FLORIDA POWER & LIGHT COMPANY

Re: Turkey Point Units 3 & 4
Docket Nos. 50-250 & 50-251
Fire Protection

The attached information is applicable to asterisked items 3.1.2, 3.1.6, 3.1.7, and 3.1.15 in the Safety Evaluation for Amendments 45 and 37 to Operating License DPR-31 and DPR-41, respectively. Information on items 3.1.1(4) and 3.1.1(5) is being developed and will be submitted by approximately December 15, 1979.

FIRE WATER SUPPLY (3.1.2)

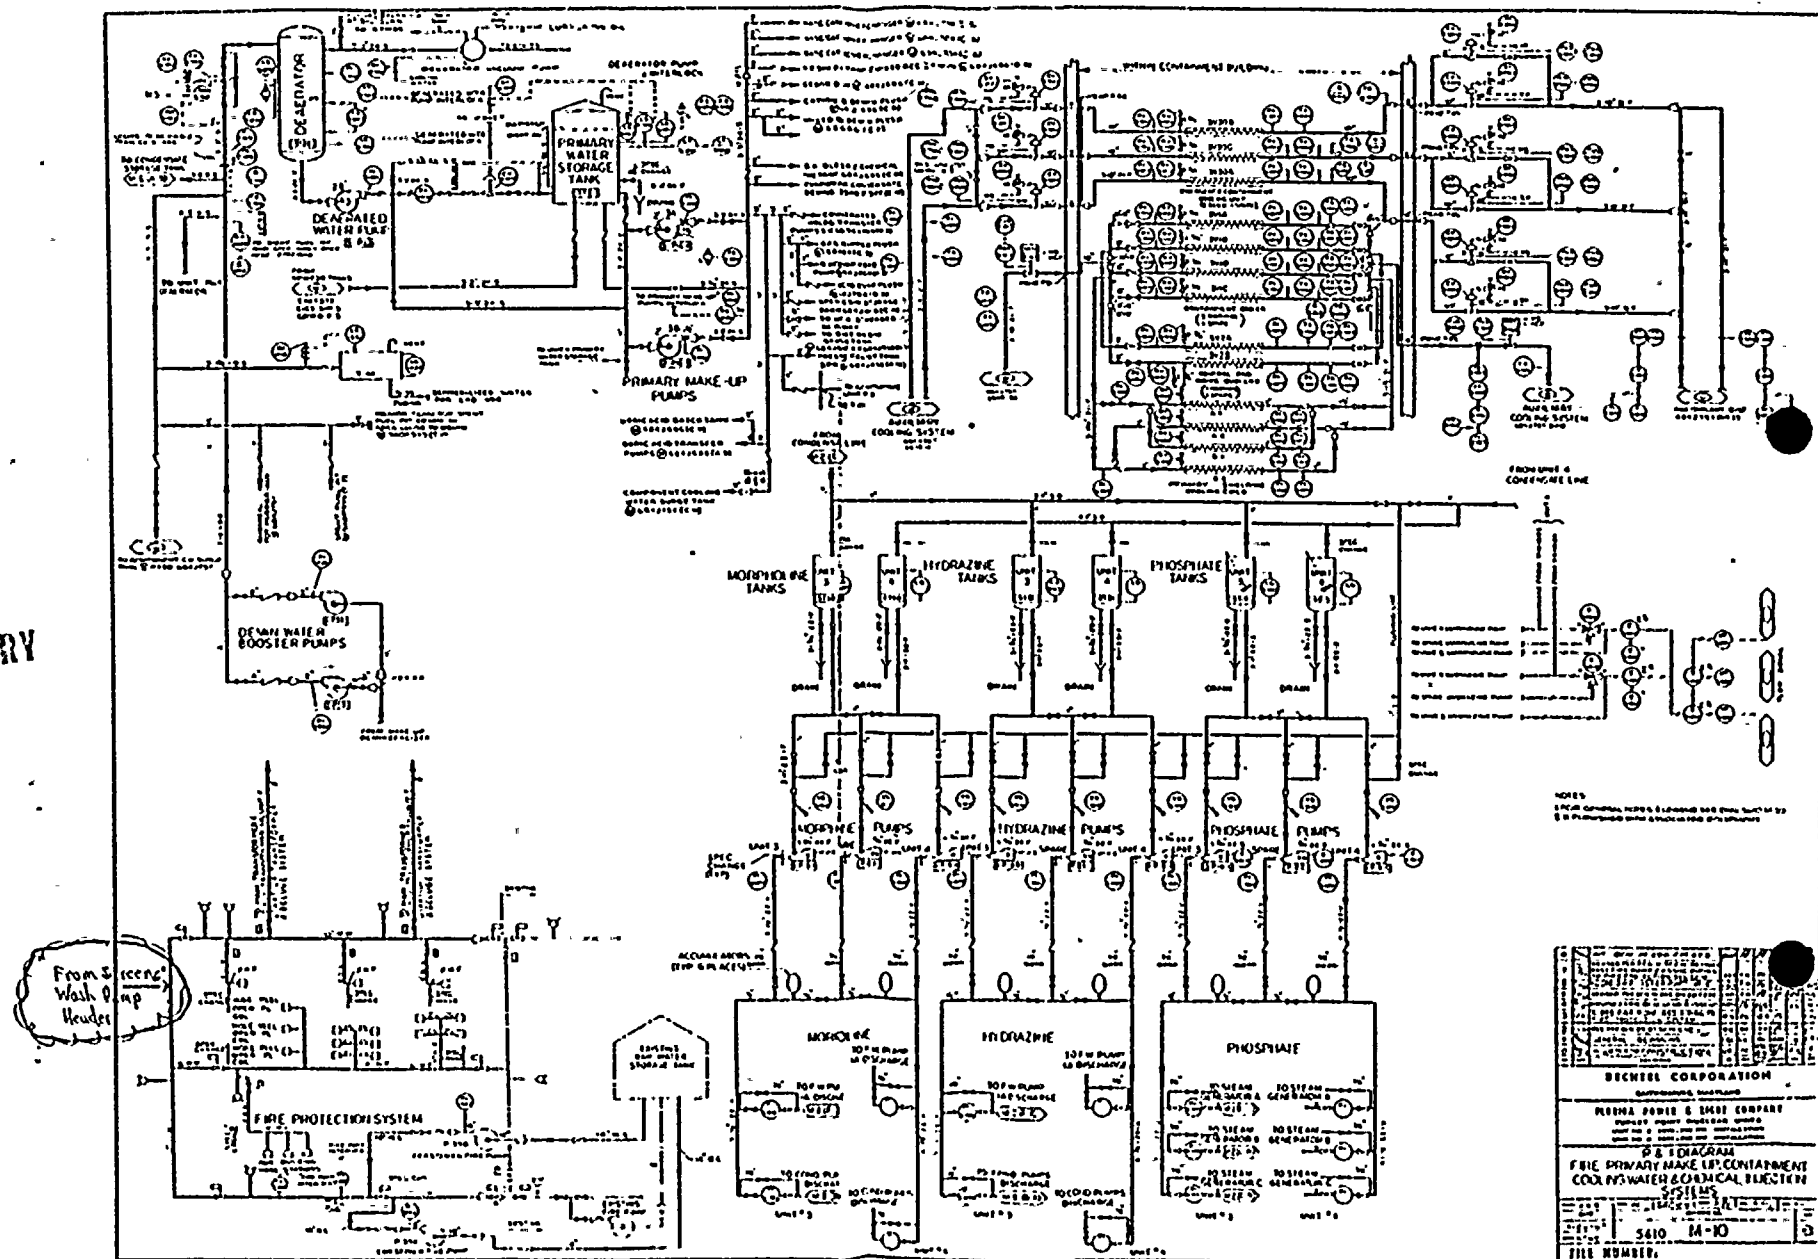
As per item 3.1.2 of referenced letter, we are transmitting herewith a copy of Bechtel Dwgs. 5610-M-5 and M-10, which have been marked up to show a 6" connection on the discharge header of the screen wash pumps as well as a 6" connection on the fire protection system main supply header. Both of these connections will terminate in a 6" fire hose fitting. In the unlikely event that water from the fire protection system normal supply is unavailable, a 6" hose will be used to interconnect the screen wash pumps with the fire protection system and thus provide an alternate source of fire water.

ATTACHMENT 2
VIEW A-A UNIT # 3
FIG. 2

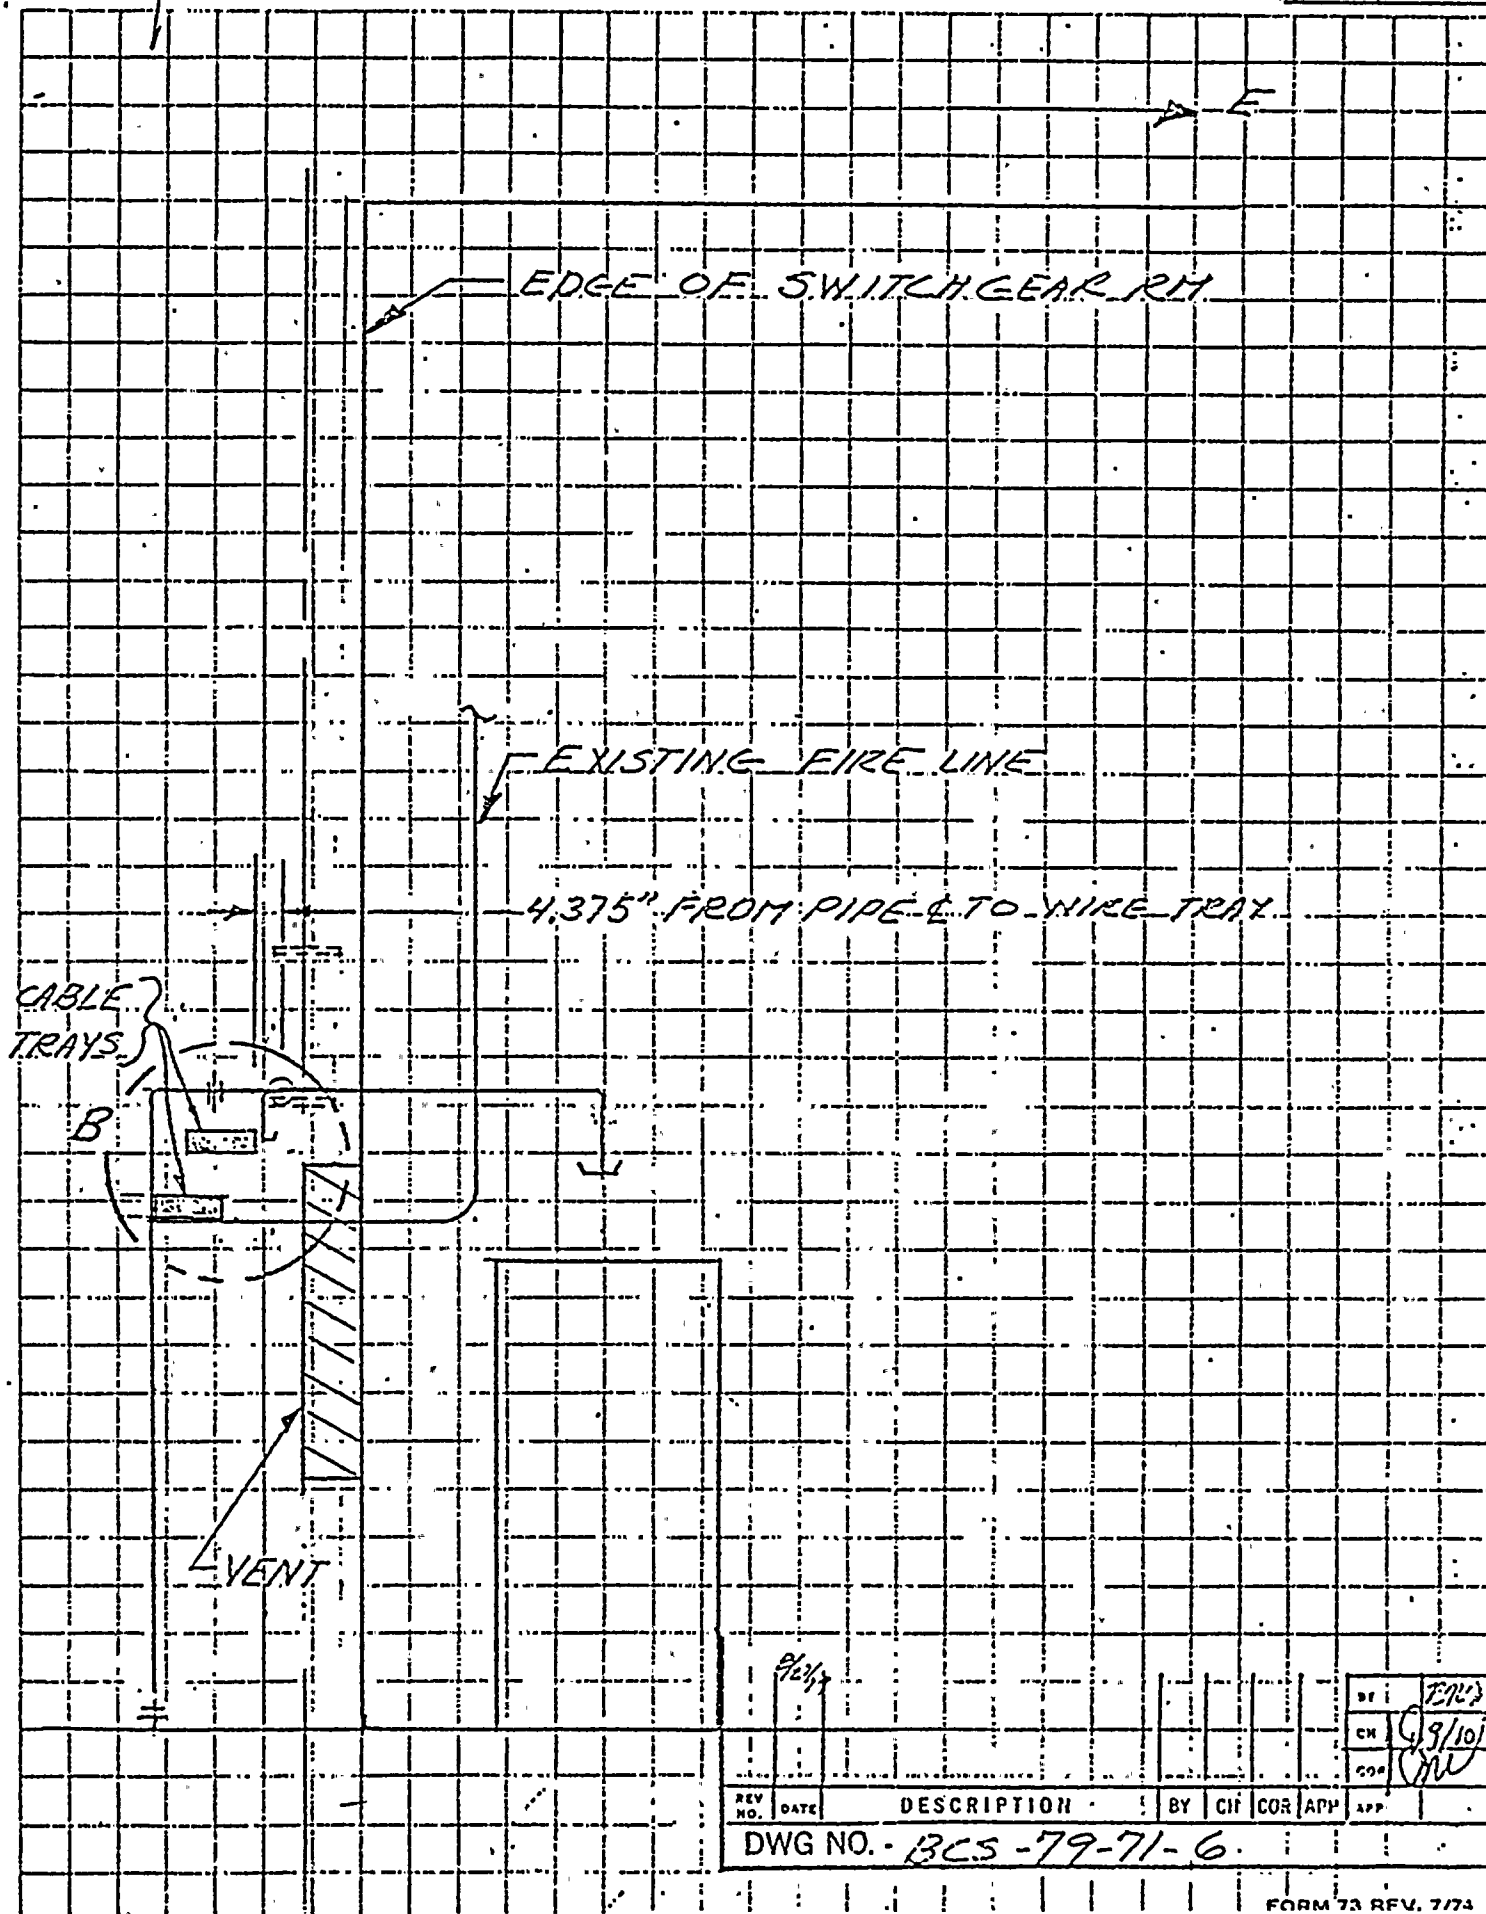
ADD A WATER CURTAIN FOR THE DOOR AND VENT OPENINGS ON THE WEST SIDE OF THE SWITCHGEAR ROOM. SEE ATTACHMENT 2

ATTACHMENT 2
DETAIL A
FIG. 5

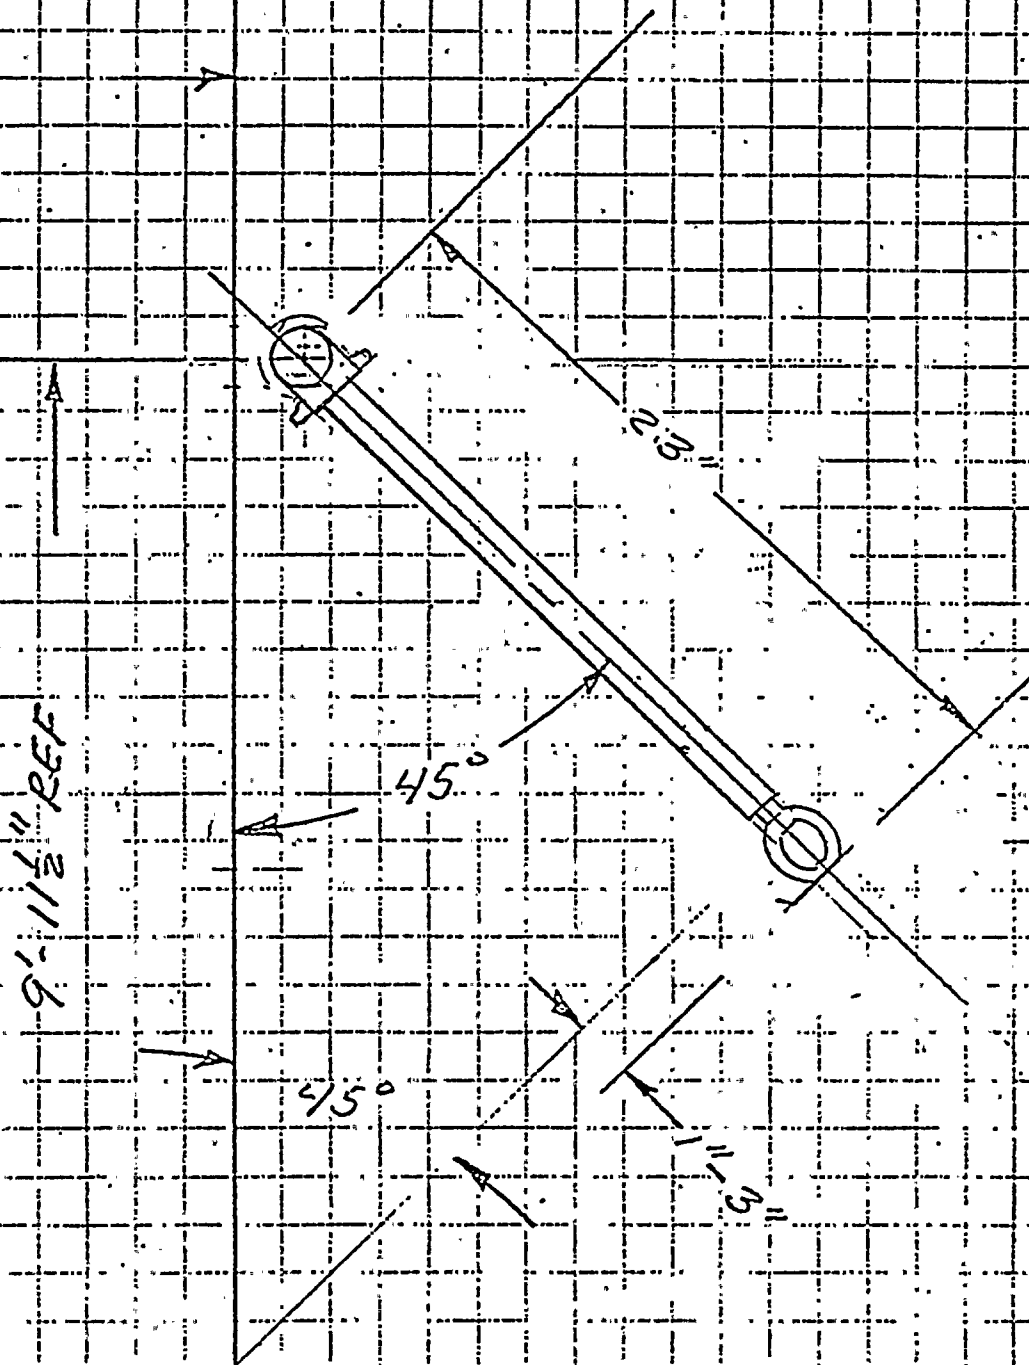
SWITCH GEAR RM WALL ABOVE
DOOR
